You've Spoken and We've Listened

Improved Locking Collar Installation

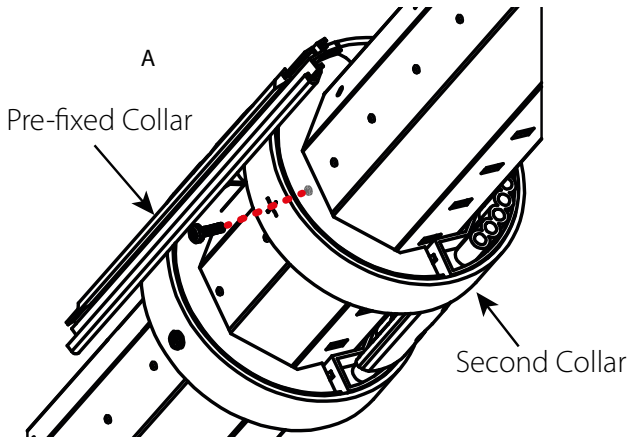
The position of the pre-fixed collars has been adjusted so that the second collar in each pair now lines up with the pre-punched holes on the axle (see **Drawing A**).

This means it is no longer necessary to drill a pilot hole when fixing the second collar to the axle.

IMPORTANT: When attaching the collars, make sure that the fixing has fully engaged with the pre-punched hole on the axle (see **Drawing B**).

The collar should fit tightly to the axle. Ensure that there is:

- No space between the inside of the collar and the axle.
- No movement from side-to-side.
